**INSTRUMENT
APPROACH
CHART**

GWANGJU/Gwangju(RKJJ)
ILS/DME
RWY 04R

Change : Information of instrument approach procedure for RWY 04R.

GWANGJU/Gwangju(RKJJ)
LOC/DME
RWY 04R

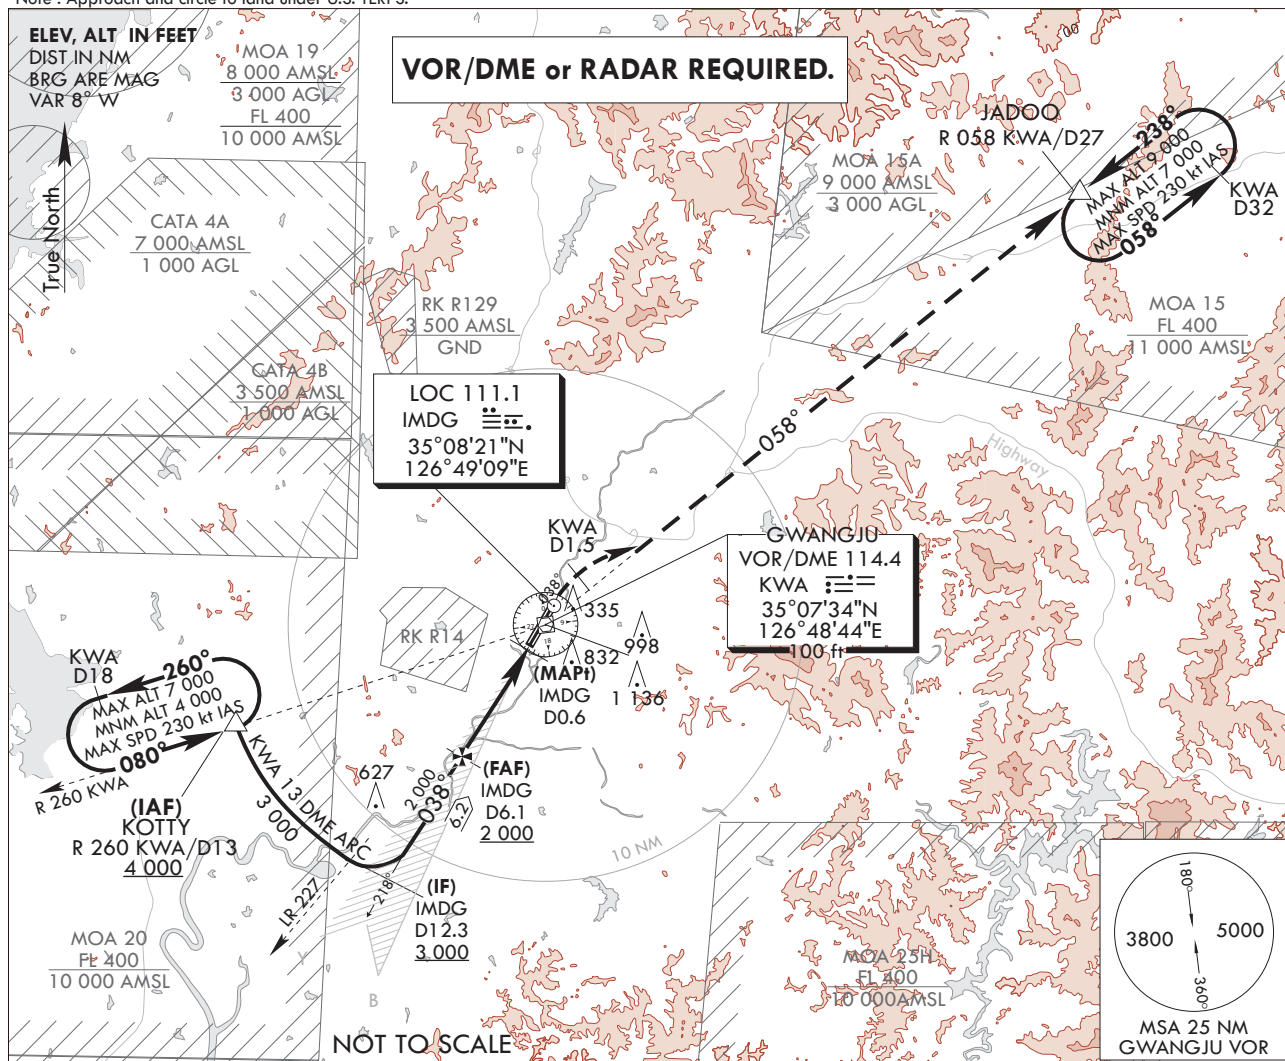
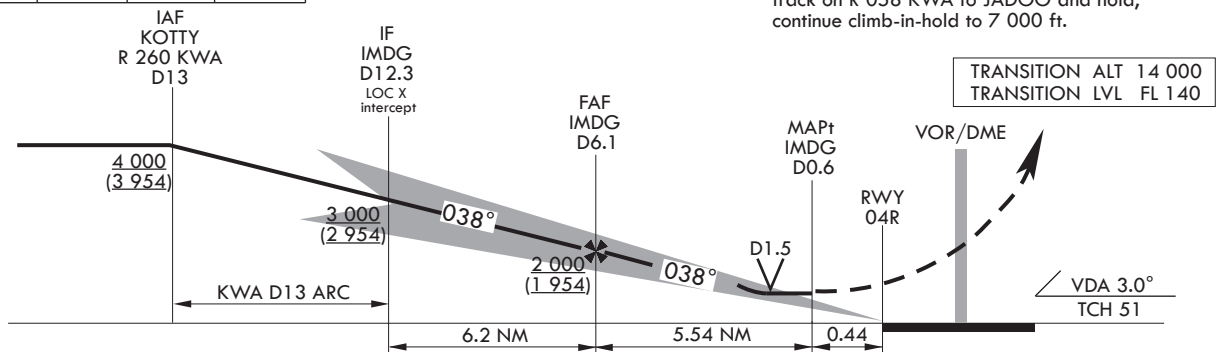
Change : Amended phrase for circling limitation.

*Circling not authorized for west of RWY 04-22.

GWANGJU/Gwangju(RKJJ)
VOR/DME
RWY 04R

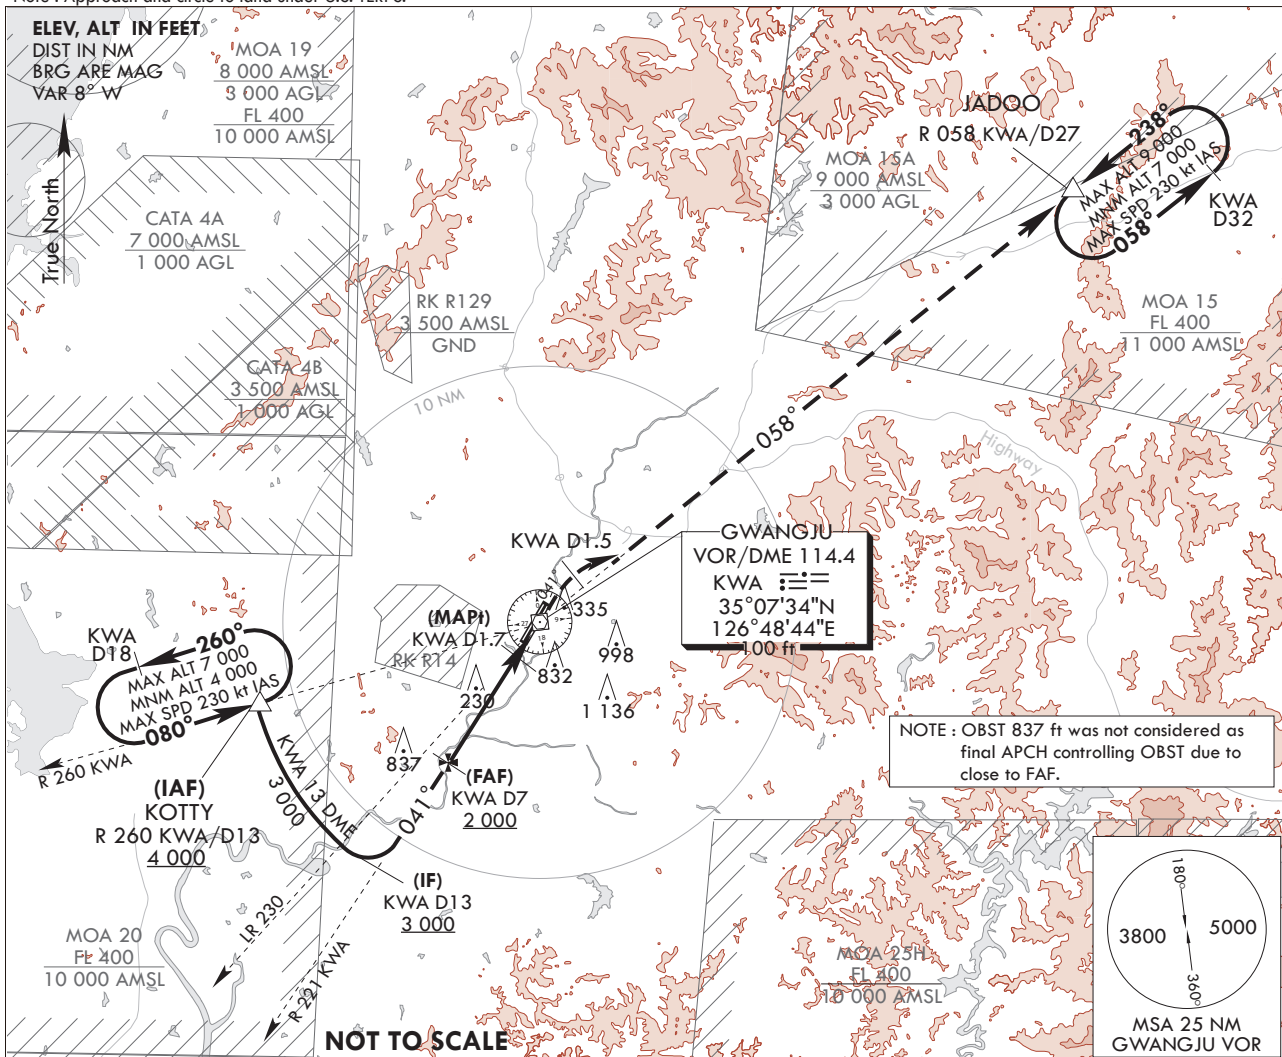
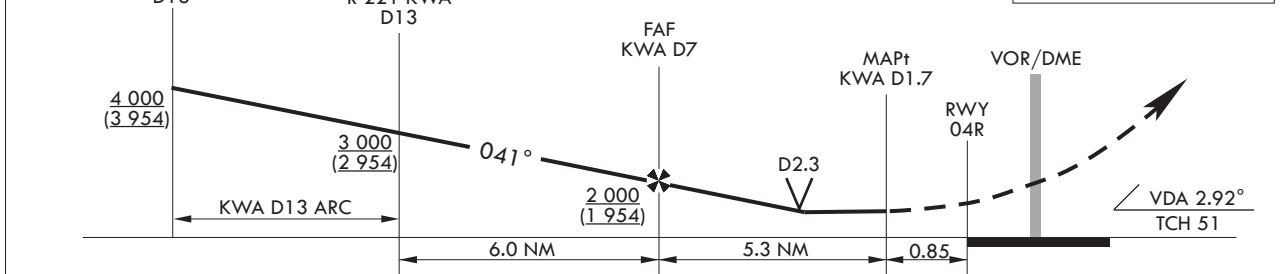
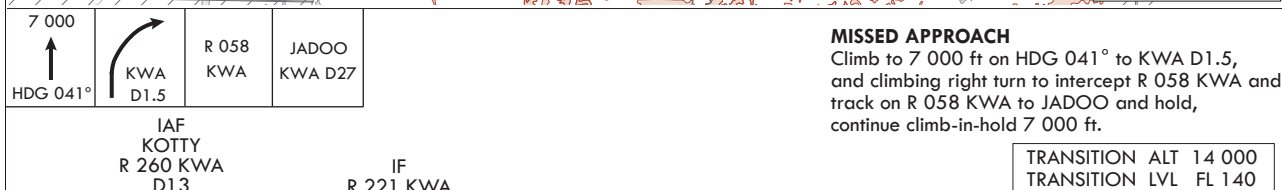
Change : Amended phrase(541 → 514).

GWANGJU/Gwangju(RKJJ)
PAR
RWY 04R

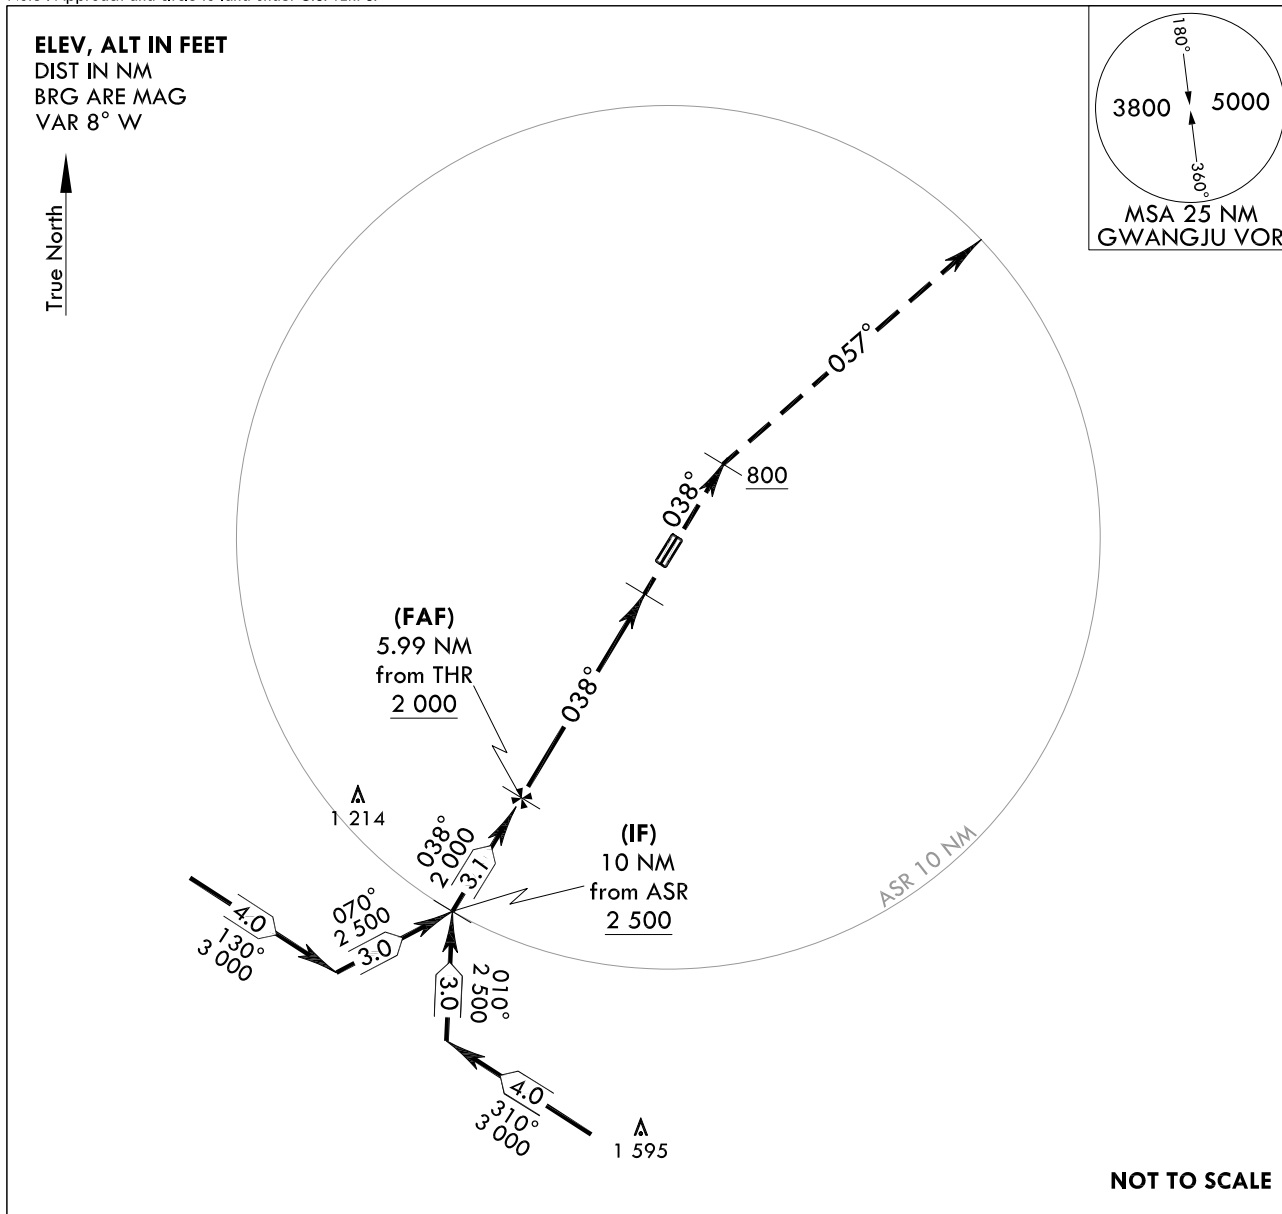
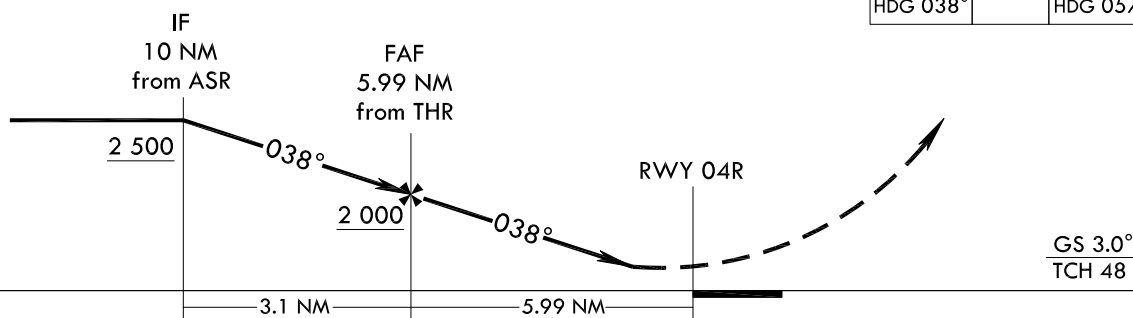
Change : Information of instrument approach procedure for RWY 04R.

GWANGJU/Gwangju(RKJJ)
ASR
RWY 04R

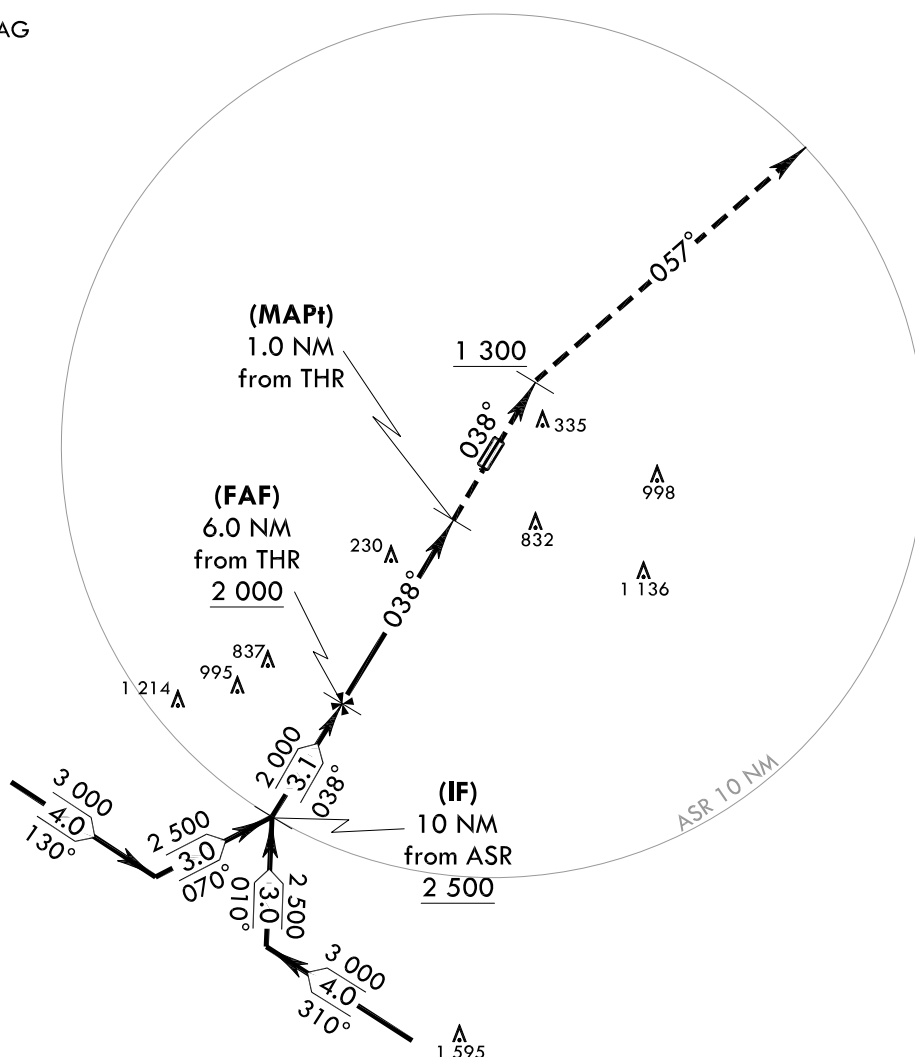
Change : Information of instrument approach procedure for RWY 04R.

**GWANGJU/Gwangju(WKJJ)
VOR/DME
RWY 04L**

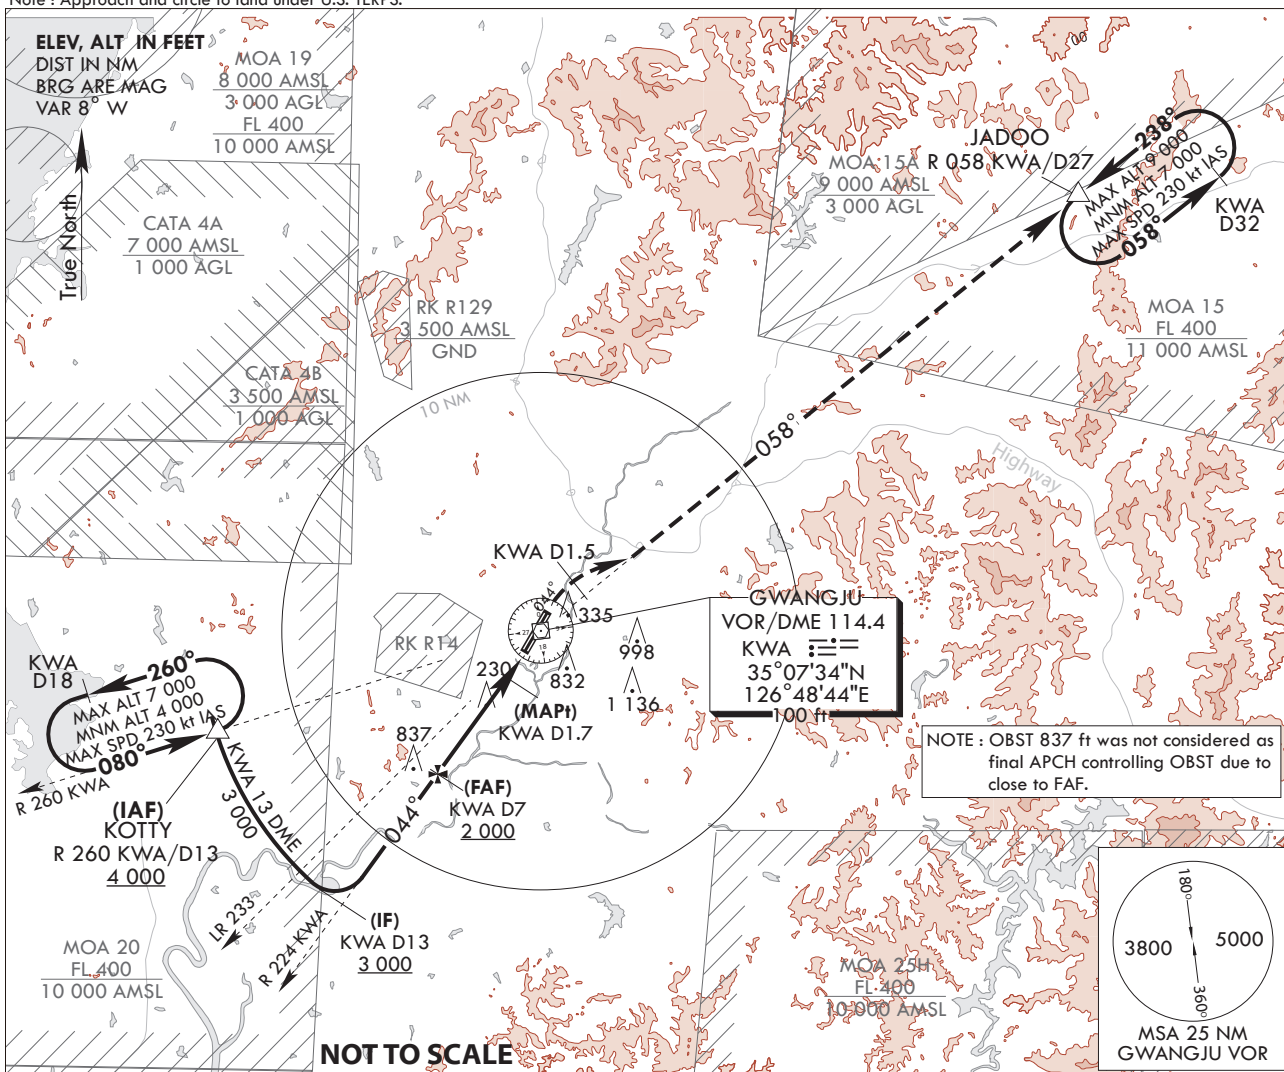
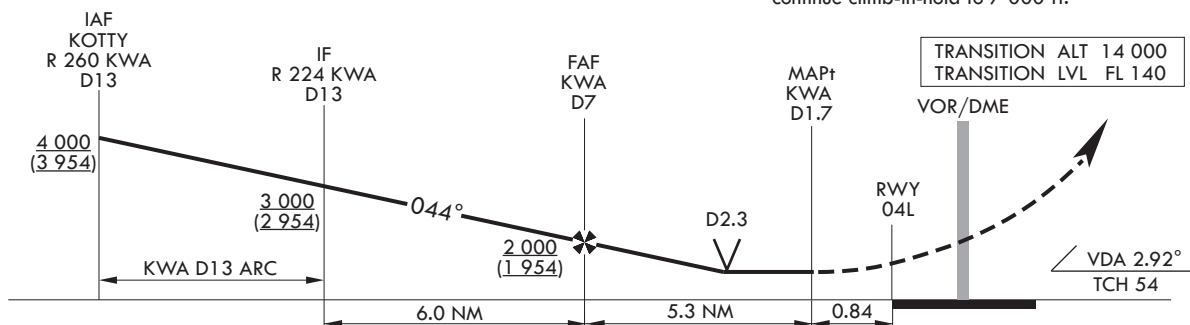
Change : Information of instrument approach procedure for RWY 04L.

GWANGJU/Gwangju(RKJJ)
PAR
RWY 04L

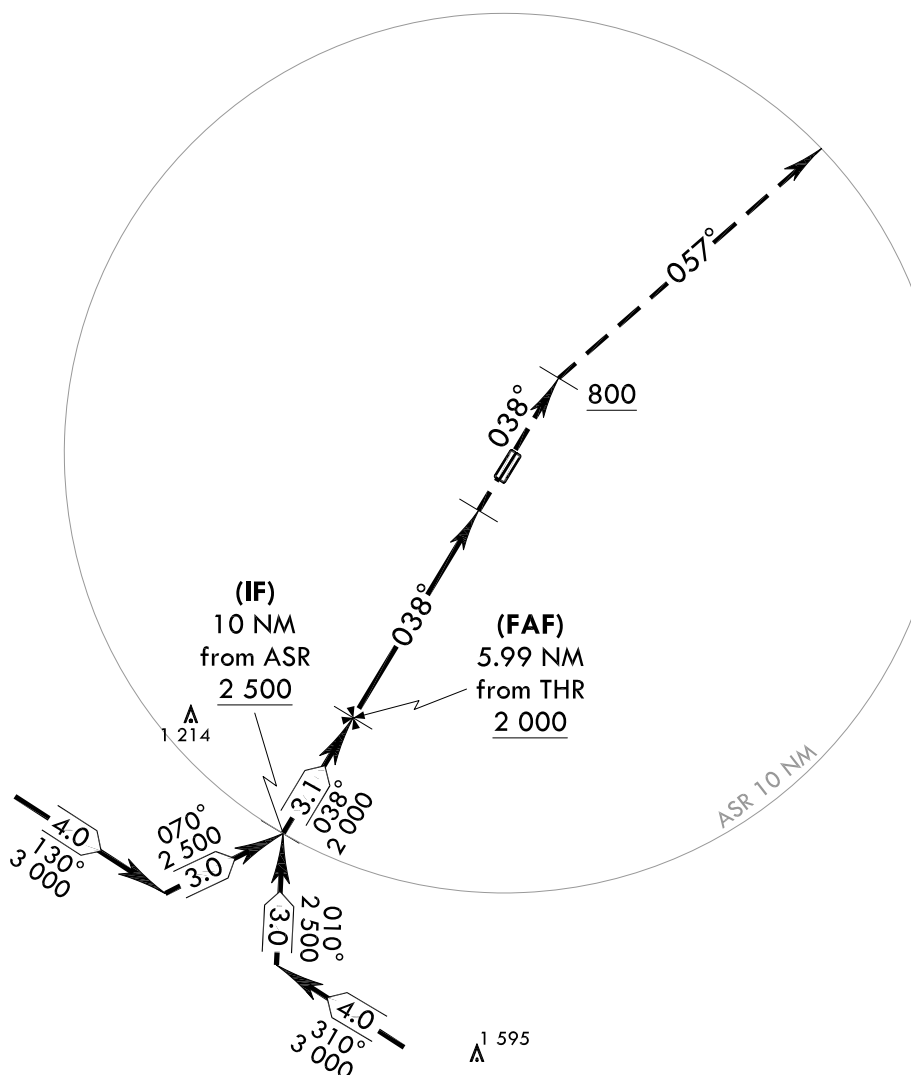
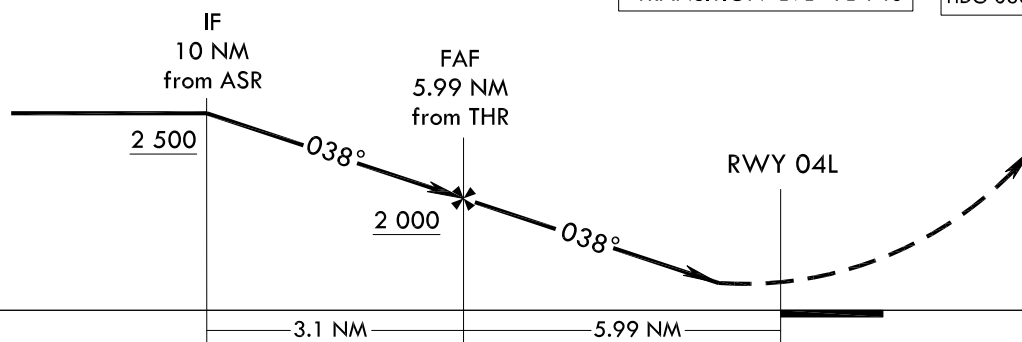
Change : Information of instrument approach procedure for RWY 04L.
